STATE OF NORTH CAROLINA
DEPARTMENT OF TRANSPORTATION

May 31, 2018

Subject: **Request for Modification to Individual Section 404 and Section 401 Water Quality Certification** for Fayetteville Outer Loop from I-95 South of Fayetteville to NC 24-87, Cumberland, Hoke, and Robeson Counties. Federal Aid Project No. NHP-0620(031), State Project No. 34817.3.13, TIP Nos. X-0002 B & C, and U-2519 AA, AB, BA, BB, CA, CB, DA, & E. Debit \$570 from WBS 34817.3.13

Subject: NEPA\404 Merger Team - Concurrence Point 4B Meeting
U-2519BA - Fayetteville Outer Loop from South of SR 1003 (Camden Road) to South of SR 1104 (Strickland Bridge Road), Cumberland County, Division 6

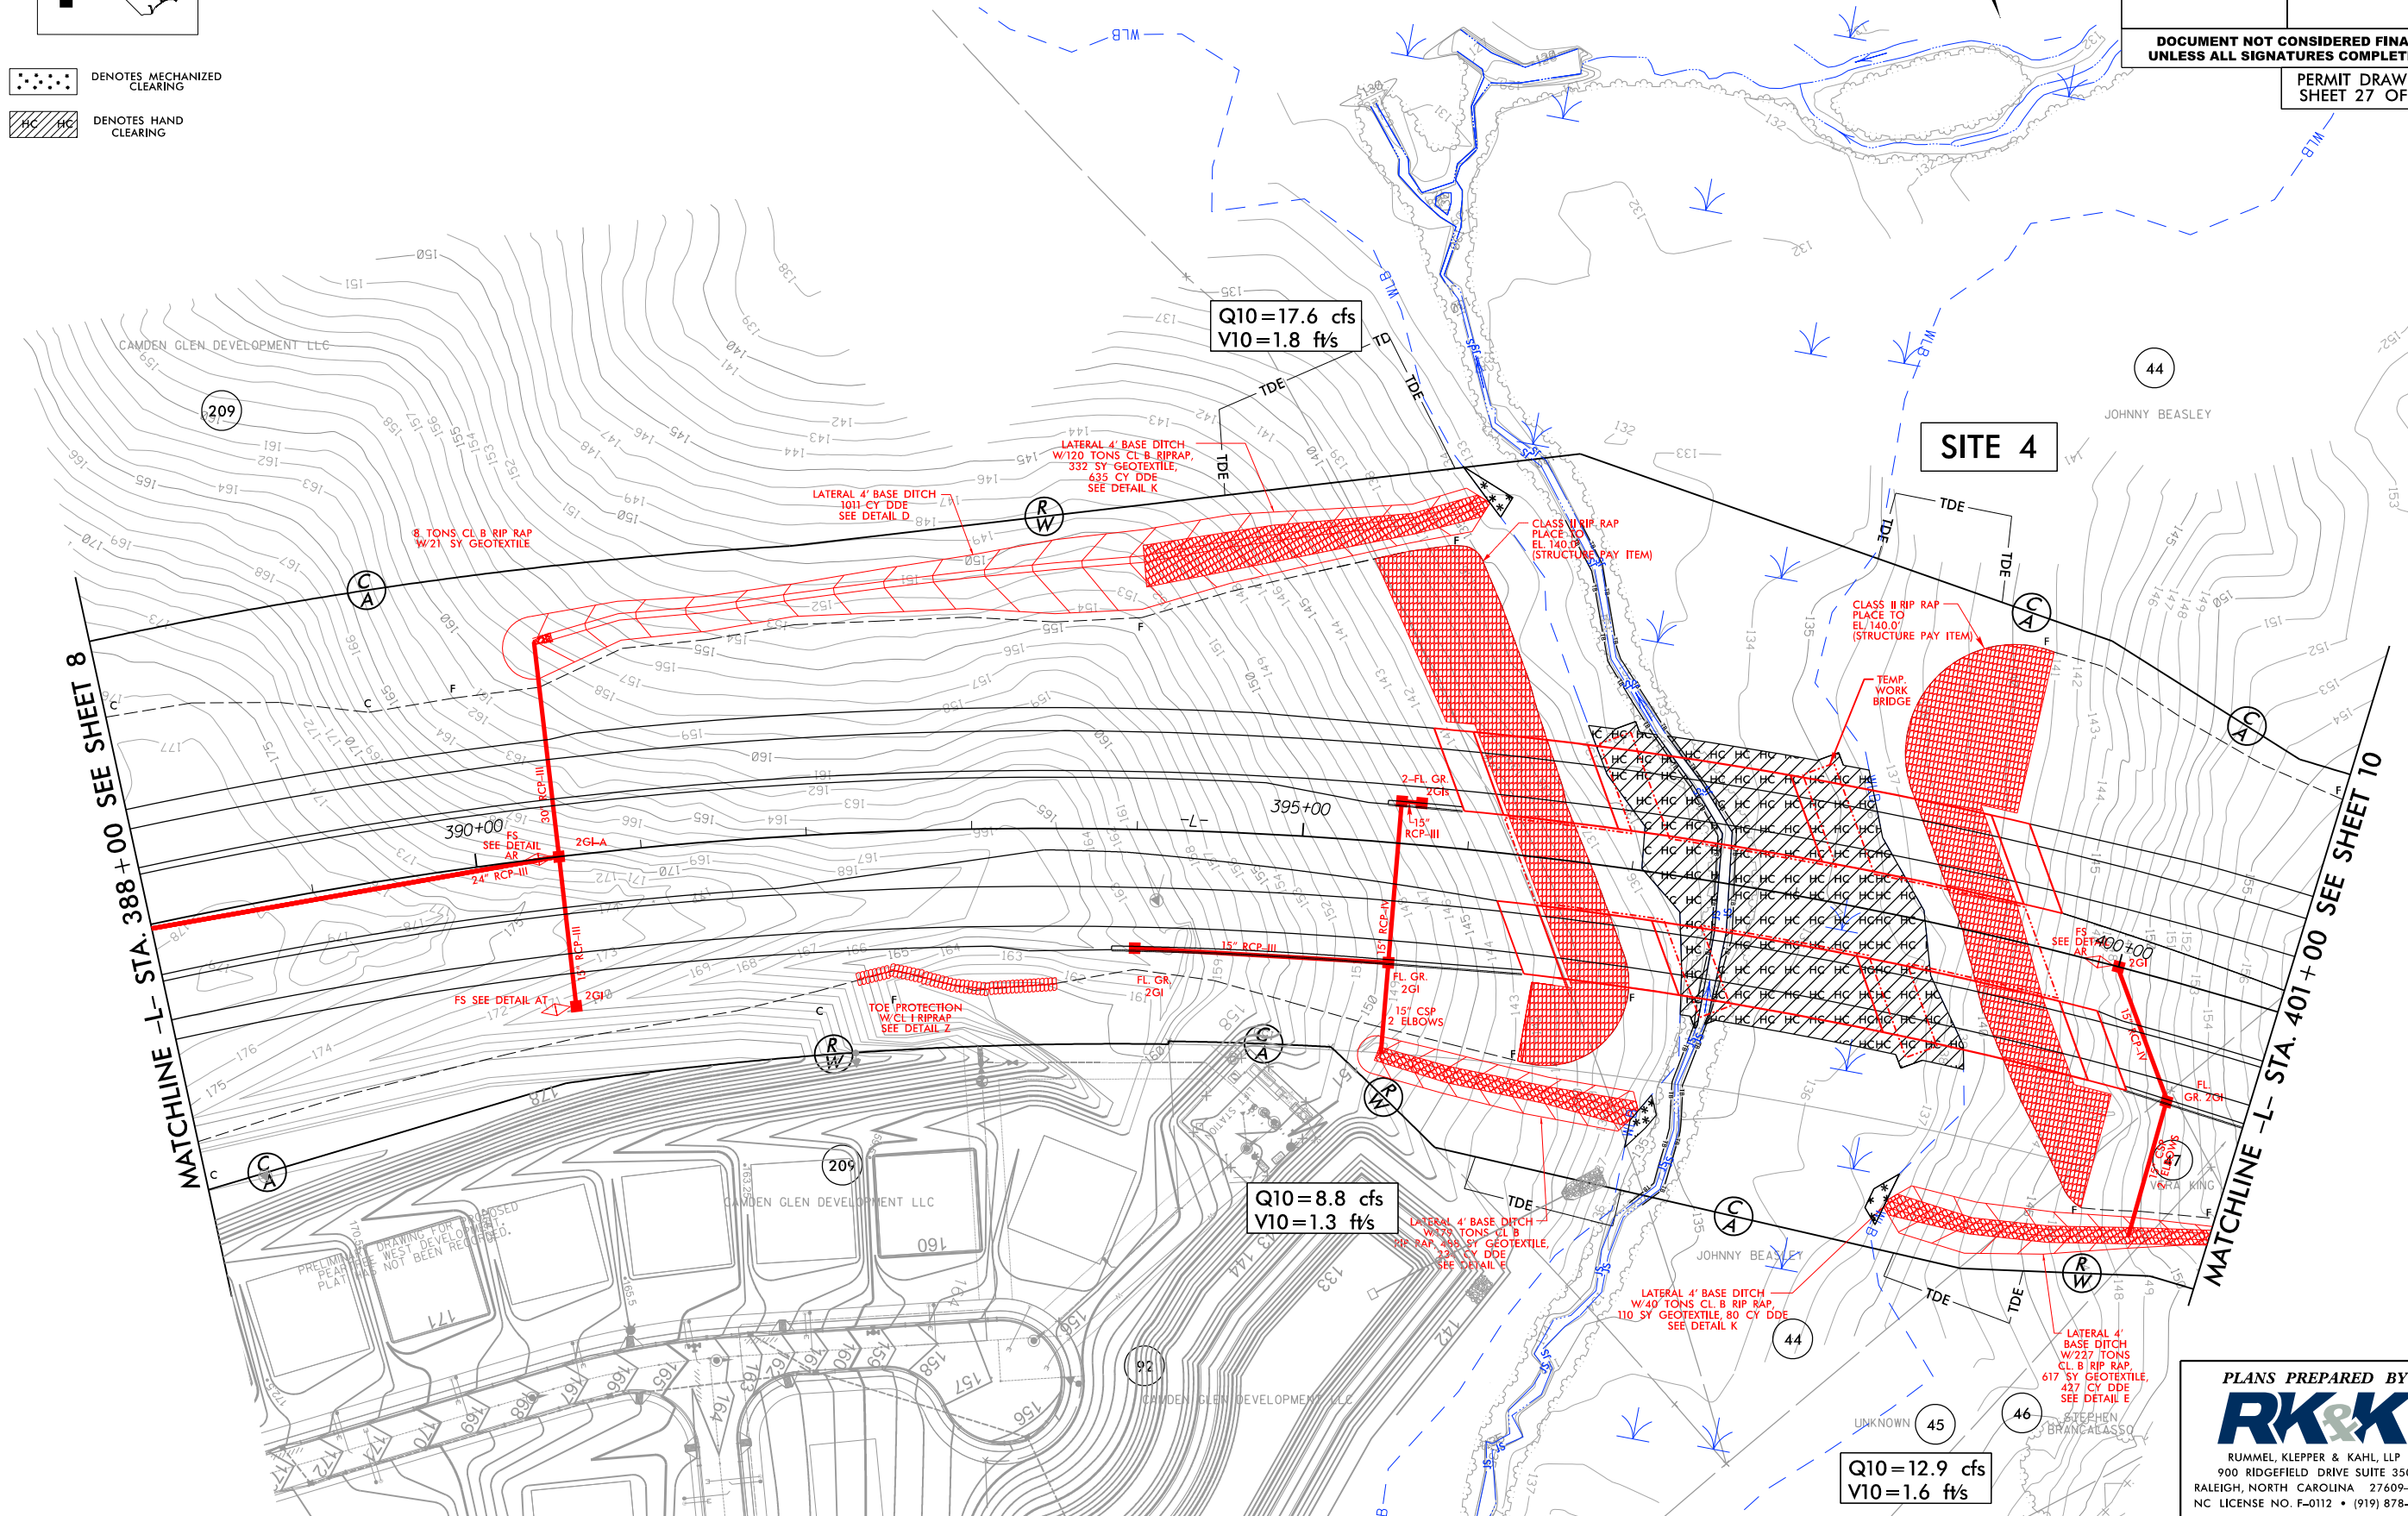
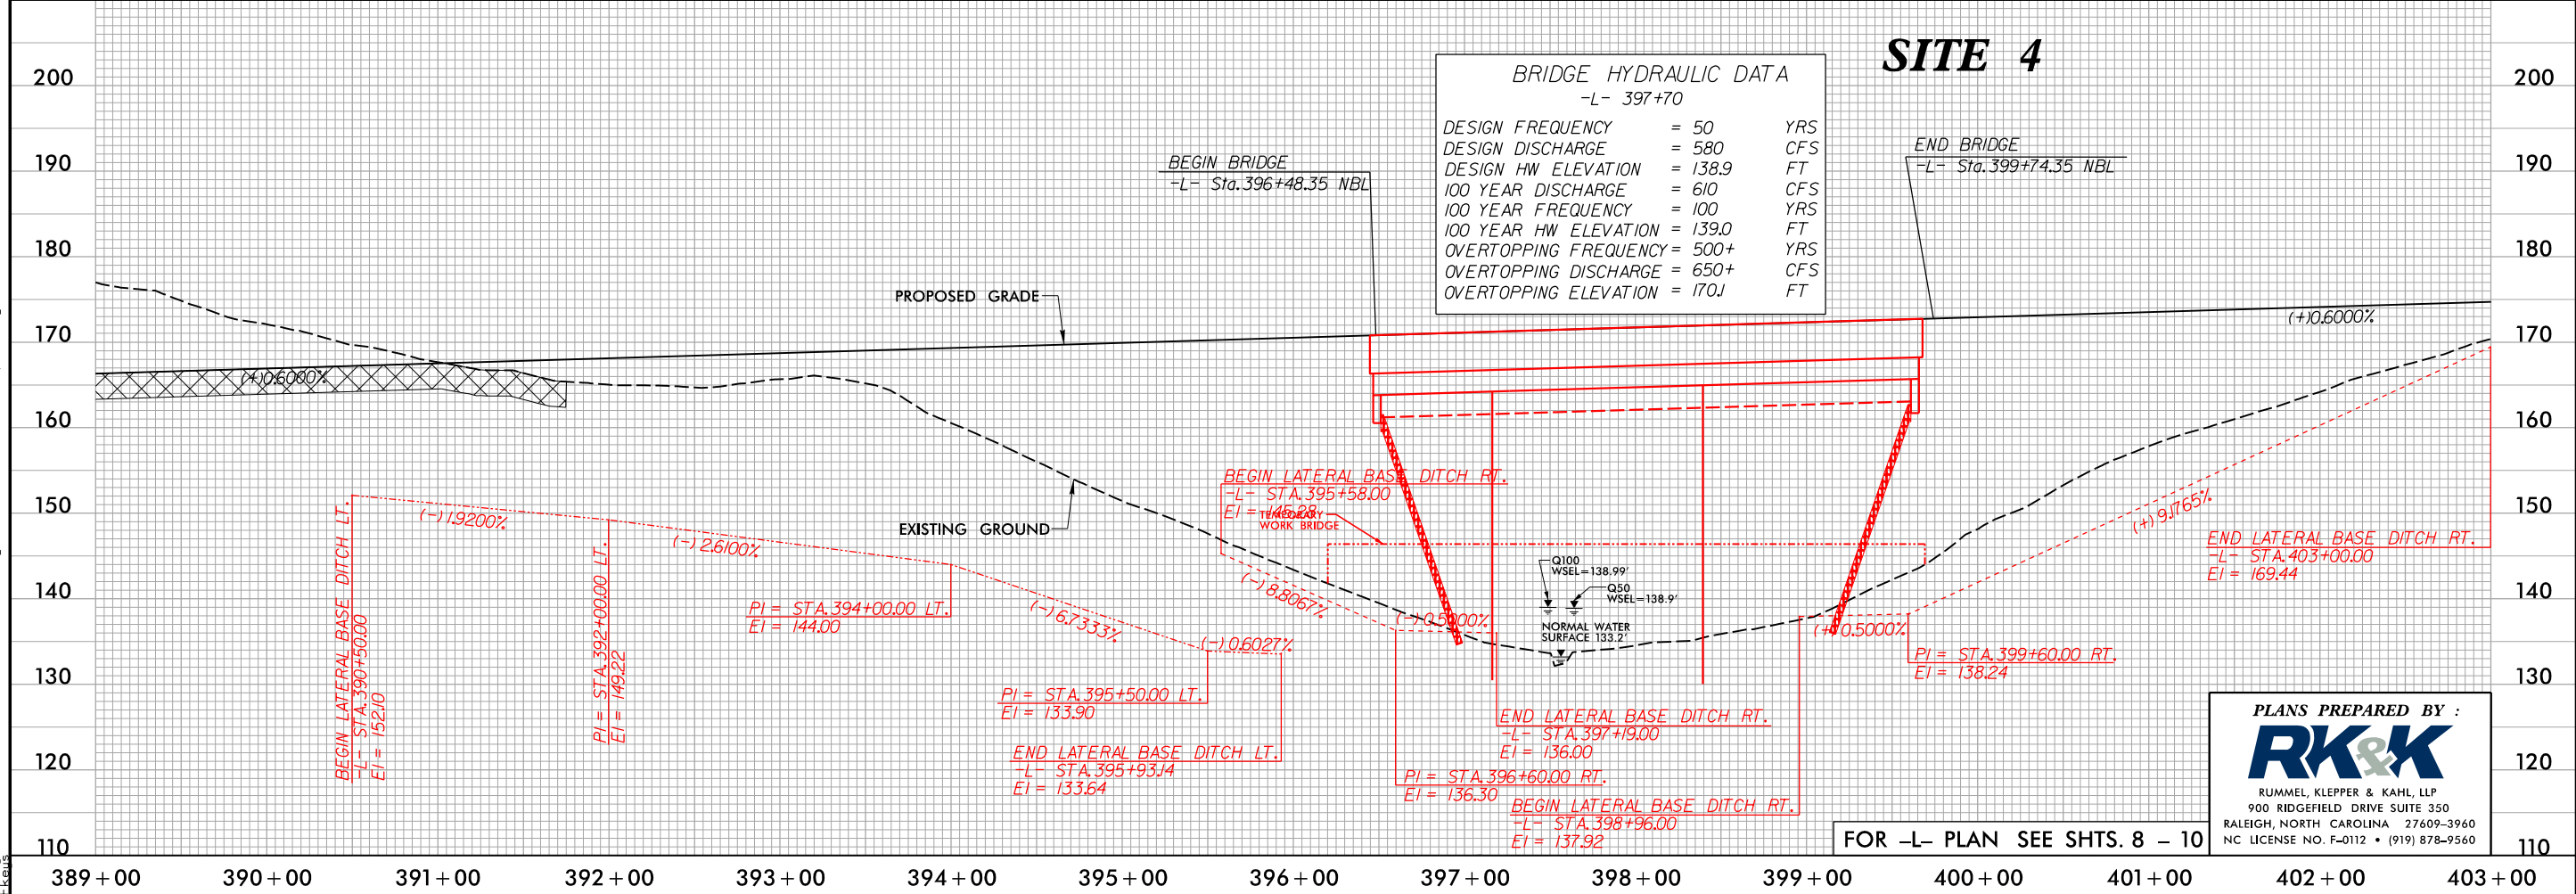
Site 4 (Permit Sheets 26-29): The site includes a bridge spanning the UT to Stewarts Creek and wetlands. No deck drains are required for the bridge. There is a minimum 15 foot offset between the wetland boundary and the toe of slope. A temporary work bridge is provided for construction and is shown on the permit drawings (dashed line under bridge). Currently the design of the work bridge is under review from the structures unit. It is noted on the final summary sheet that the work bridge impacts are not final until approval of the work bridge.
